**PROOF OF EVIDENCE of RICHARD MUIR (MSc BSc CEng MIOA MIMechE)
of SANDY BROWN LIMITED on behalf of the Medical Research Council**

Noise and Vibration

- 2.1 I have been engaged by the MRC Laboratory of Molecular Biology (LMB) to advise on noise and vibration matters associated with The Network Rail (Cambridge South Infrastructure Enhancements) Order (CSIE). My evidence deals primarily with the works at Cambridge South station and the associated track works component as this is most relevant to the LMB.

- 2.2 My evidence is a review of the Environmental Statement (ES) and supporting information pertaining to noise and vibration prepared by Ramboll on behalf of Network Rail. My evidence will cover noise and vibration from the operation once completed and also temporary noise and vibration during construction. I have conducted baseline noise and vibration monitoring at the LMB to provide an independent baseline survey. Network Rail have provided supplementary technical updates of the ES relating to noise and vibration and I have considered this as part of my evidence. I have also attended meetings with Network Rail and their technical team to discuss noise and vibration matters.

Figure 4 Amplification factor from the ES

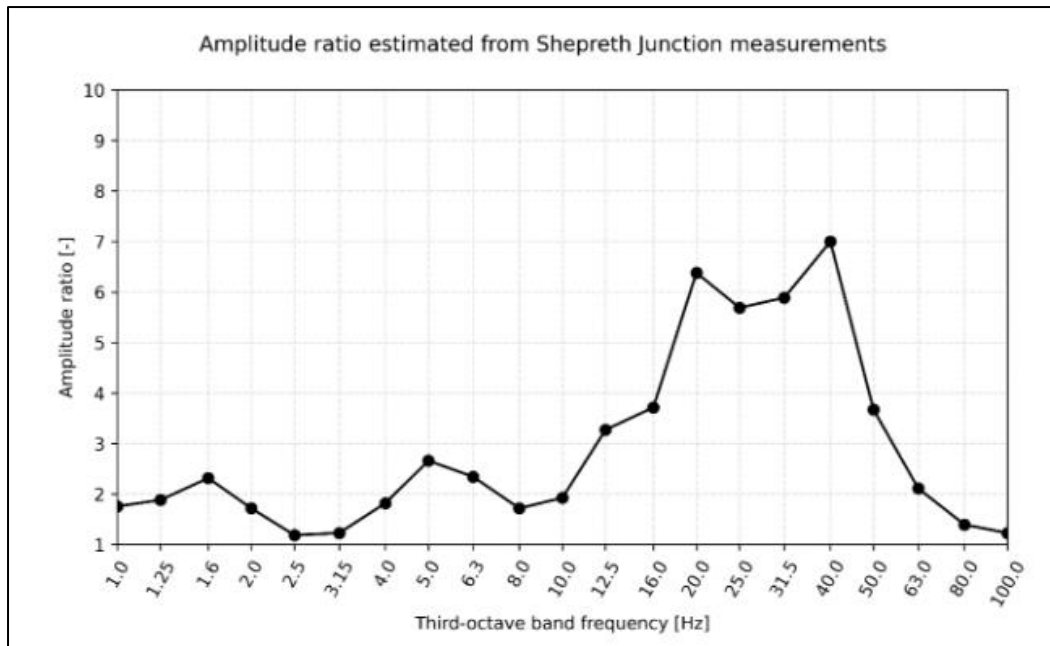
- 5.13 Appendix 6.3 details the assessment of the effect of switches and crossings. This is assessed by applying an amplification factor to account for the increase in vibration from the switches and crossings and to apply a correction for distance from the switch and crossing to the LMB. The amplification factor has been determined by a comparison of measurements taken at Shepreth Junction with another section of straight track at similar distance located 500m away from Shepreth Junction. These comparative measurements indicate a sevenfold increase in vibration amplitude.

- 5.14 The assessment of Shepreth Junction does not provide any detail of the speed and length of the trains recorded, nor whether this assessment included the effect of freight trains.

- 5.15 The amplification factor from the ES is shown in Figure 4. The modified vibration levels have been corrected for distance to the LMB building. The revised predicted vibration levels at the LMB from the ES are given in Figure 5 . This shows an increase in vibration from VC-D to VC-B at location 1 (Cryo EM) and from VC-C to VC-B at location 2 (west wing laboratory). This increase is assessed as significant requiring further unspecified mitigation measures which could include modification to the crossing geometry and track supports or vibration isolation tables for the sensitive equipment in the LMB.

Figure 5 Effect of switches and Crossing from the ES

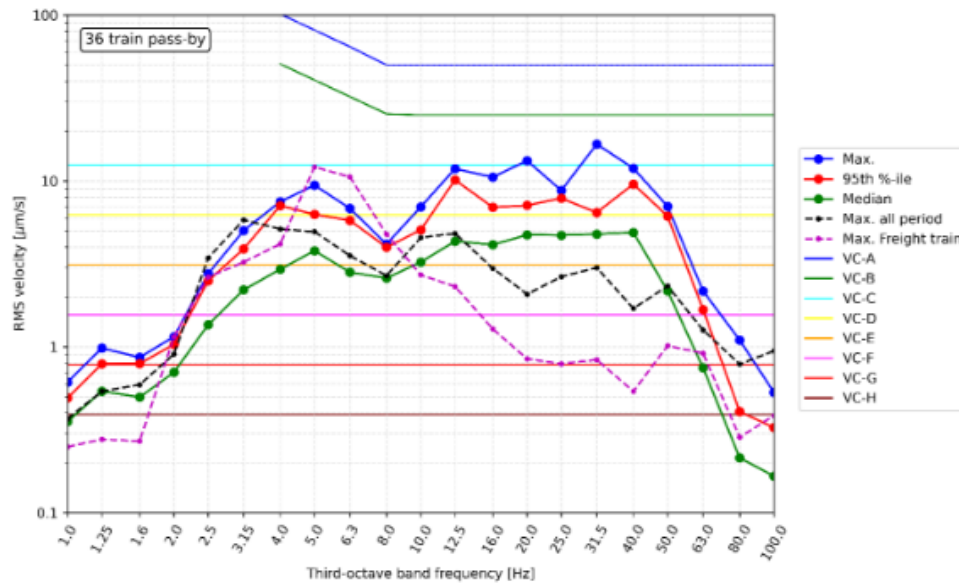
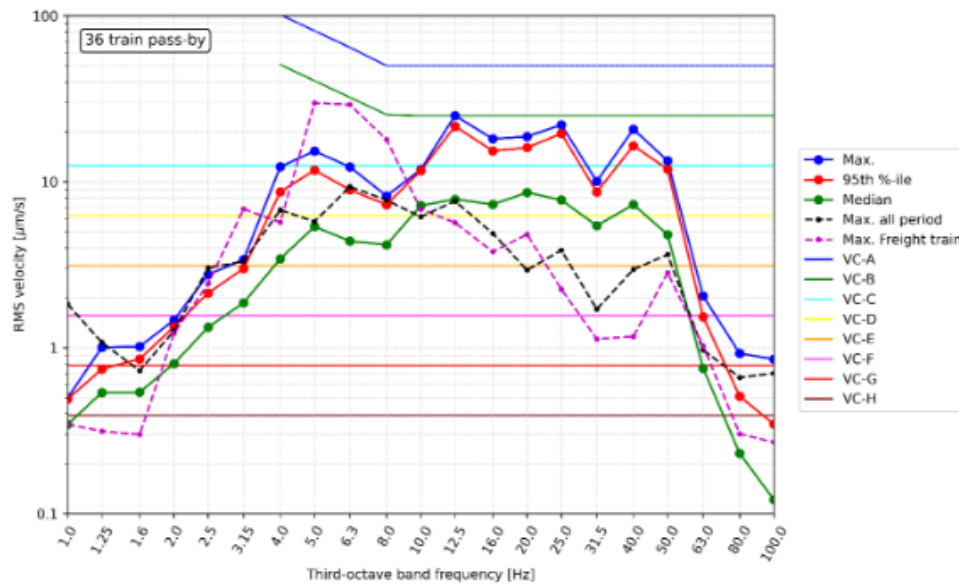
- 5.17 Under 6.4.15, the ES states that for the LMB a residual impact is predicted requiring further mitigation. This understates the predicted impact. The predicted residual impact is an increase in vibration of 2 VC bands from VC-D to VC-B which is classed in the ES as a major impact for a high sensitivity receptor resulting in a significant vibration impact (it is a major increase to move between bands and here there is a two-band difference).

Figure 6 Extract from RIVAS 2013 (Figure 2.29a)

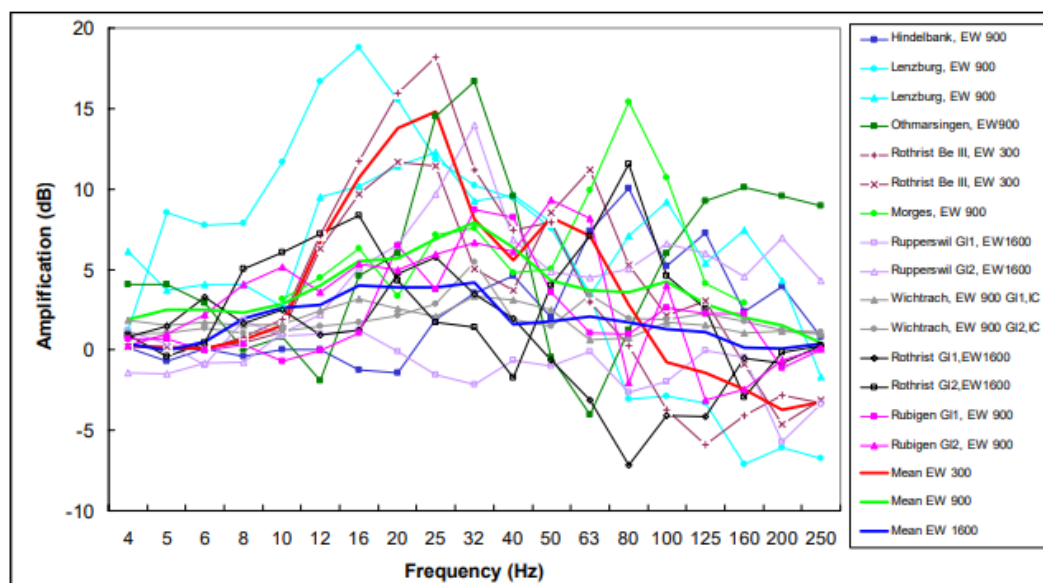
5.23 The technical update considers the RIVAS 2013 research paper⁴ which provides supporting research that indicates that amplification factor measured at Shepreth Junction is pessimistic. This is mainly because the geometry in terms of the turnout radius is much tighter at Shepreth Junction (300 m) than that proposed (1,200 m). The refinement of the amplification factor has reduced the amplification factor from 7 to about 2 which is a significant change.

- 5.24 The RIVAS research paper referred to in the assessment does conclude that based on mean measurements there is a relationship between vibration amplification and geometry including turnout radius. However, there is still high variability in this data as can be seen from data from the same paper (but on the previous page) shown in Figure 6. Reviewing this data, I also note that some measurements of 1,600m radius turnout resulted in an amplification factor of 5. This paper also indicates that geometry, ground conditions and maintenance status have a strong influence on turnout amplification and the paper quotes differences of a factor of 3, or higher, can occur. The paper also suggests that the amplification factor is dependent on speed and increases by a factor of 3 from 25 mph to 50 mph. The revised single point source propagation is reasonable but needs to be verified by synchronised measurements at varying distances from the points which has subsequently been carried out by Ramboll (see next section).
